### **TAGGART EARTHMOVING LTD APPLICATIONS - RESPONSE TO S 92 REQUESTS**

Thank you for your 22 December 2020 requests for further information for resource consent applications CRC204106, CRC204107, CRC204143 and CRC211629 (made to Environment Canterbury) RC205105 (made to Waimakariri District Council).

### Response to questions from Waimakariri District Council

### Response to questions from Environment Canterbury

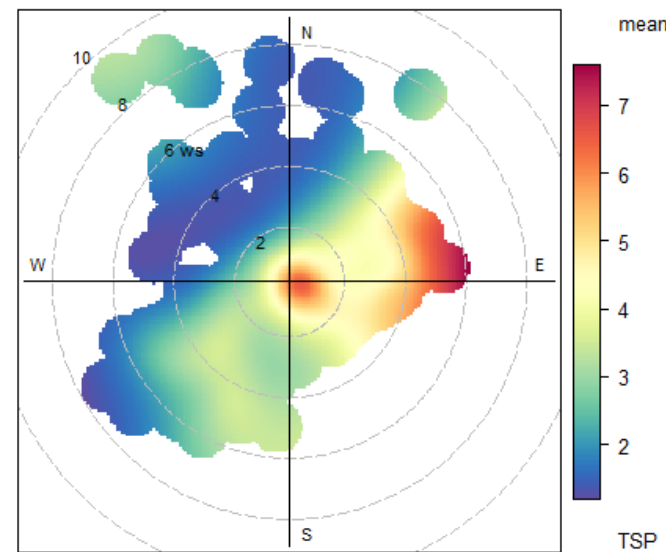
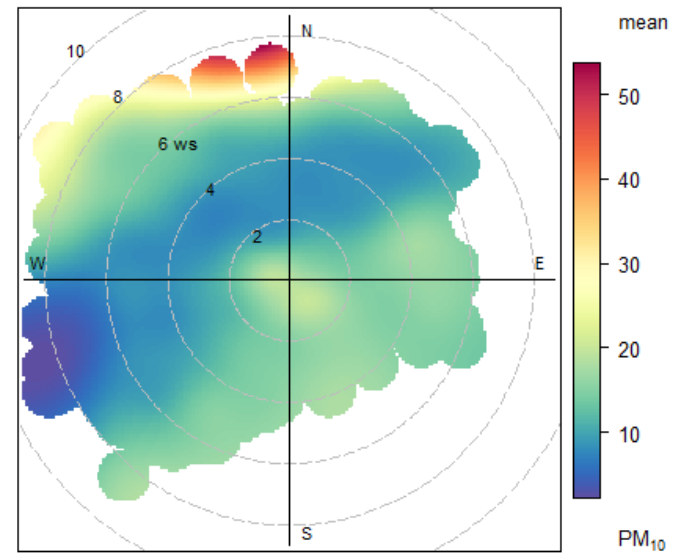
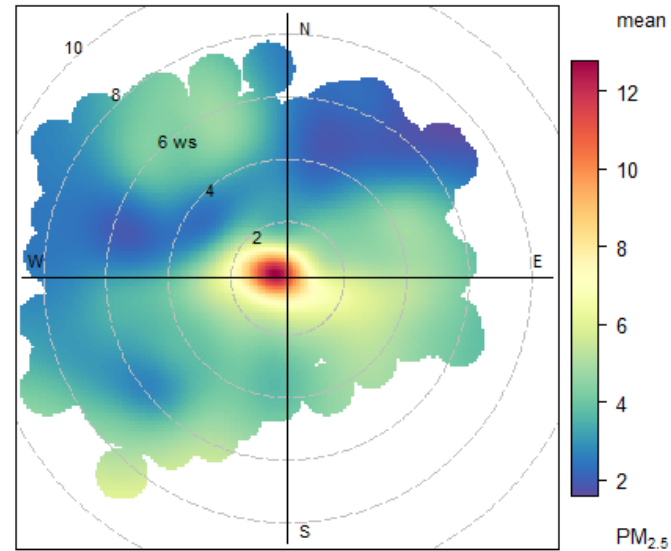
**Given there is potentially multiple dust sources in the area, how is it proposed to monitor dust from the site? For example, is it intended to isolate dust discharges from the site from other potential sources? Or will the proposed dust triggers apply to the cumulative dust discharges occurring from the site and elsewhere?**

Based on the activities that surround the proposed site, PDP has identified the following potential sources of dust:

Since late December 2020 PDP has been undertaking TSP monitoring on the western boundary of the site. The figure below presents 1-hour average concentrations of three variables wind speed, wind direction (measured at Rangiora by ECan) and TSP. A coloured dot is placed over the grid for each possible wind direction and speed, with red representing relatively high concentration of TSP and blue indicating low concentrations.

As indicated by the figure below, the highest TSP concentration occur during stronger easterly winds. While there is dust from all directions, the appears to be no other significant source of TSP nearby other than the residential dwellings to the east.

ECAN measures  $PM_{10}$  and  $PM_{2.5}$  near St Josephs School in Rangiora and the images below present the last 3 years of 1-hour average data measured at this location. These figures indicate that highest concentrations of  $PM_{10}$  are coming from the north and  $PM_{2.5}$  concentrations appear to be very localised. Given that the maximum  $PM_{10}$  concentration occur during strong winds ( $>6$  m/s) from the

north and northwest, and there is no significant increase in  $PM_{2.5}$  concentration from this direction could indicate that the source of the  $PM_{10}$  is from the Ashley river.

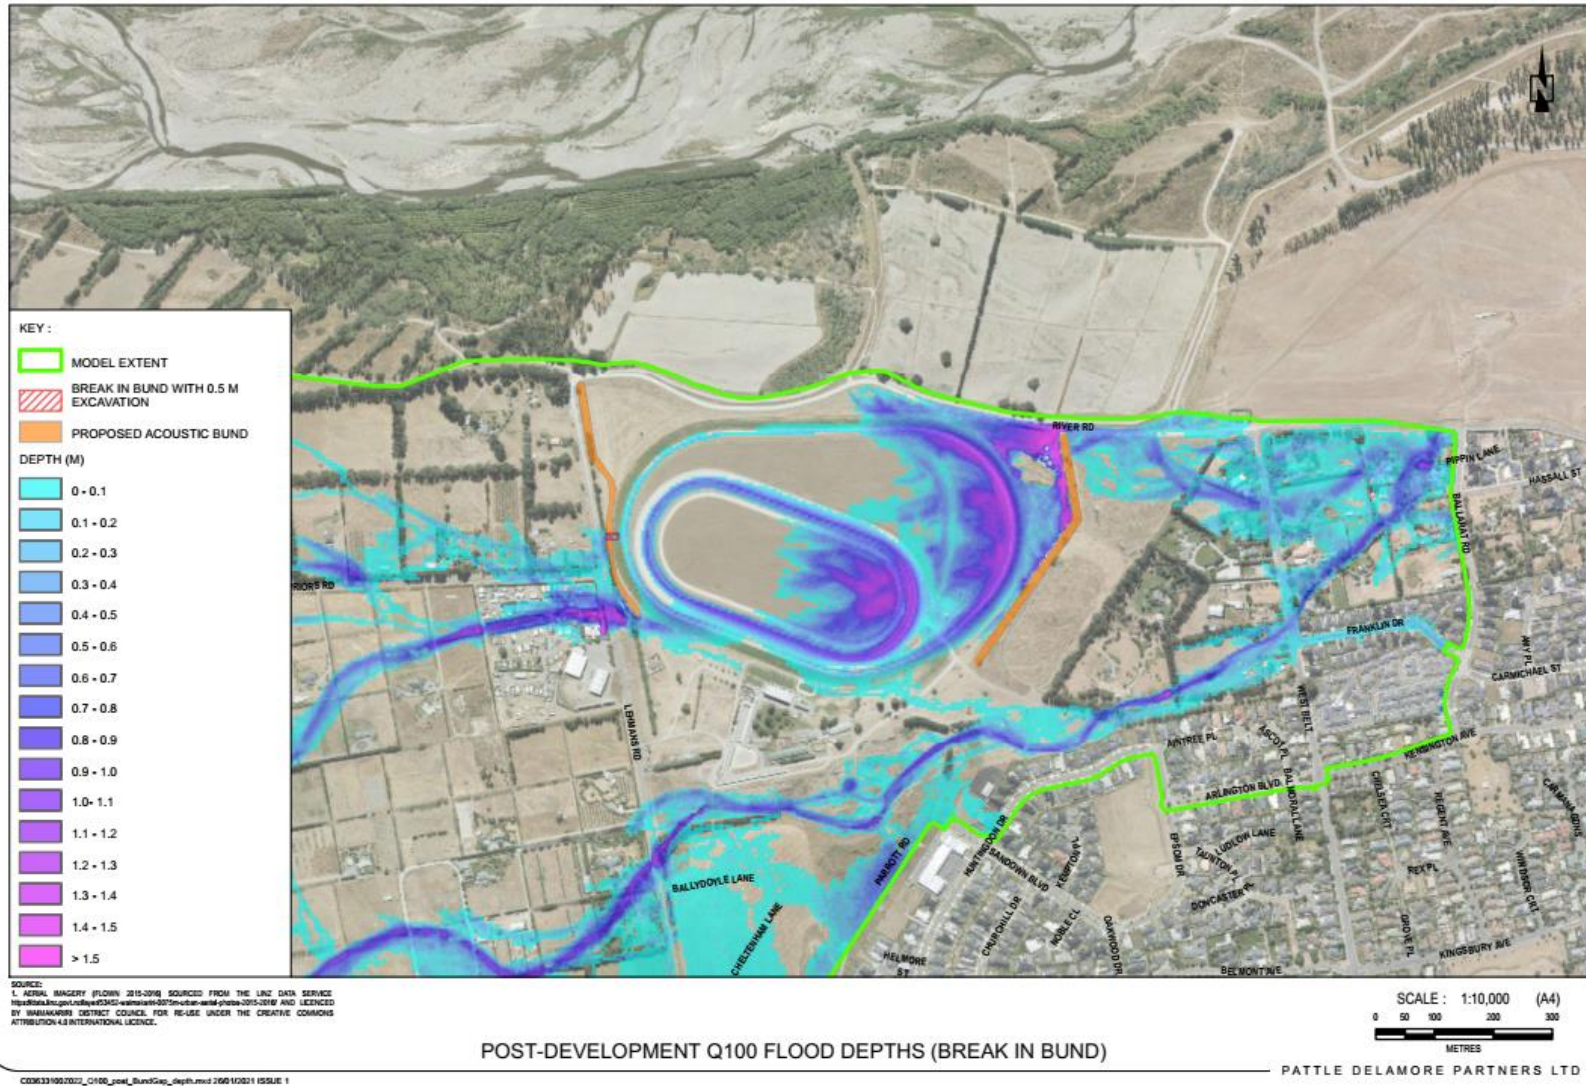
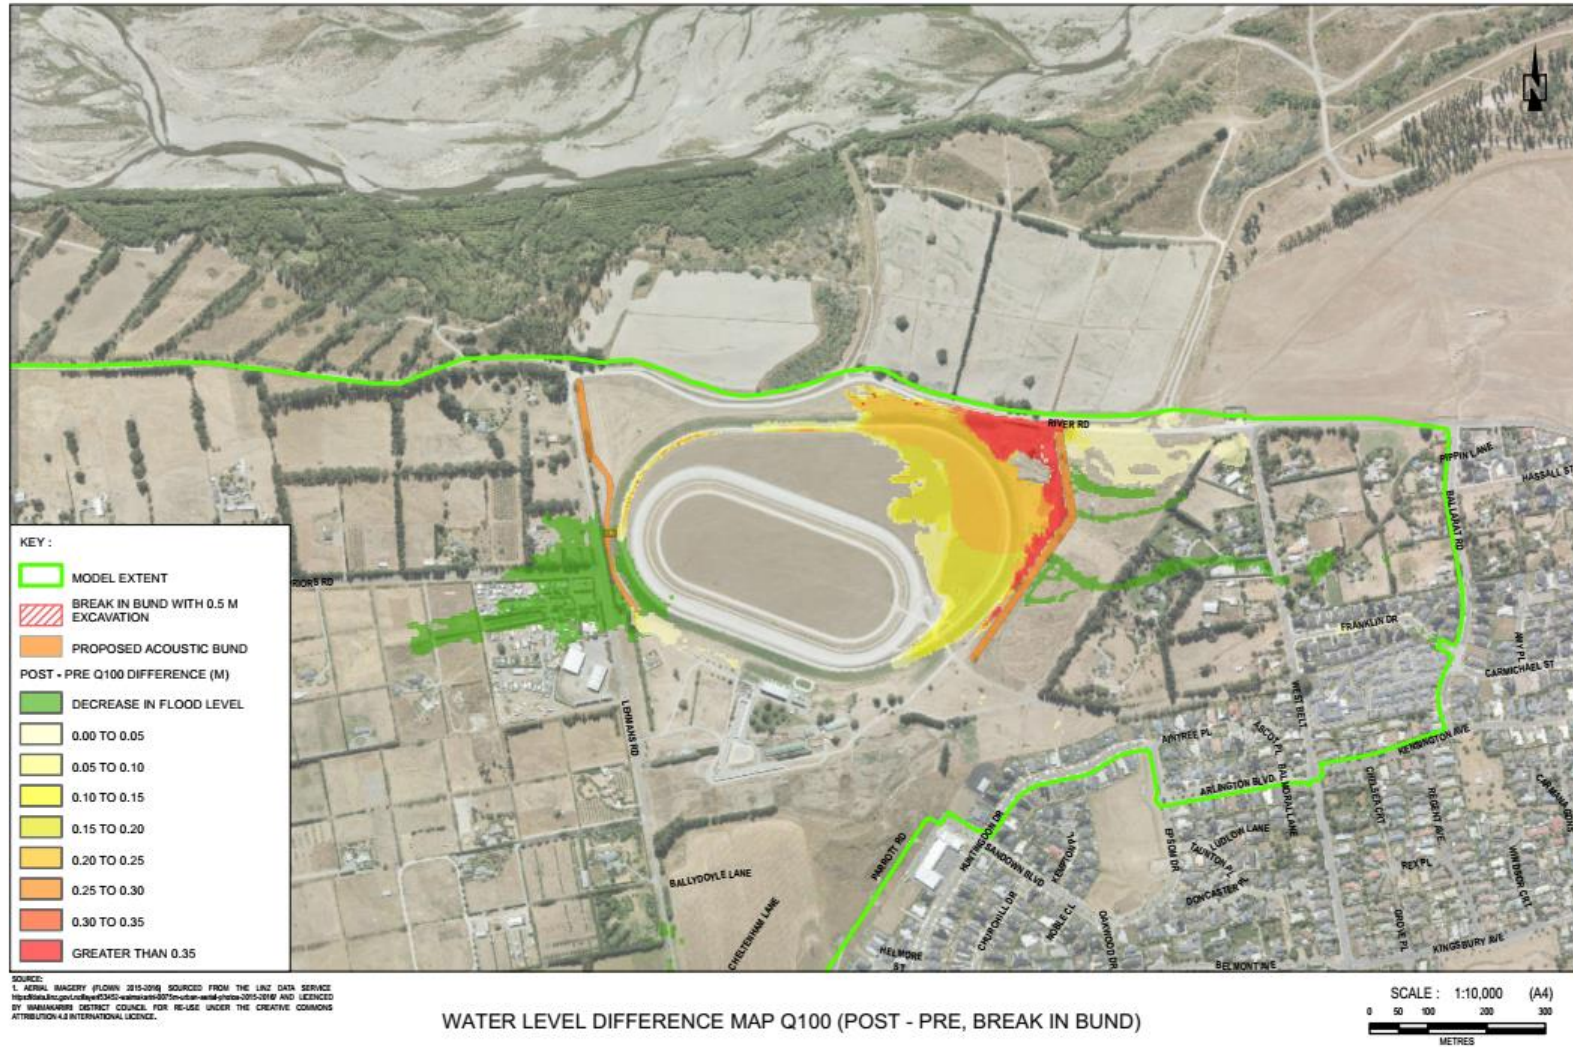
In order to understand the implications of the modelling result and assess the proposal against the policies of the Waimakariri District Plan, please provide a site specific assessment of each habitable dwelling and ancillary building where flooding is shown as increasing and demonstrate that the reduction in freeboard is acceptable at each property.

6. The application has provided an assessment of the potential increases in the depth of flooding as a result of different magnitude flood events however, it is not clear if the

In the event of a flood warning or flood event, Taggart could undertake works to excavate a portion of the western bund, to allow flood waters through to alleviate flood effects on the Lehman Road properties. A new Condition 14 of the proposed conditions (Attachment 5) has been added to require this as follows:

PDP has undertaken flood flow modelling under this scenario to show the efficacy of this measure. Mapped results of that modelling are presented in Attachment 4.

PDP has undertaken preliminary re-modelling of flood water diversion during a Q100 event. The scenario shown in the two figures is to be compared with the flood modelling results attached to the AEE.

In the scenario modelled and shown below, the western bund is deliberately breached and a 10 m wide gap excavated in the location shown (approximately opposite the dwelling at 359 Lehmans Road). This gap is accompanied by a 0.5 m excavation below ground level. Ordinarily the bund would remain intact, and these excavation works would be undertaken immediately in the event that Environment Canterbury issues a flood warning for the Ashley River/Rakahuri. The intent of the works is to create a preferential flow path for flood waters flowing west to east and entering the vicinity of 359 Lehmans Rd. This gap is intended to allow flood waters to enter the Racecourse site rather than be diverted by the bund.

The two figures below show the efficacy of the bund breach. The first figure shows actual modelled flood water depths during a Q 100 event. The second figure shows the difference in flood water depths between a breached and unbreached bund, with a reduction in flood water diversion and depth shown throughout the area around the Lehmans Rd/Priors Rd intersection.
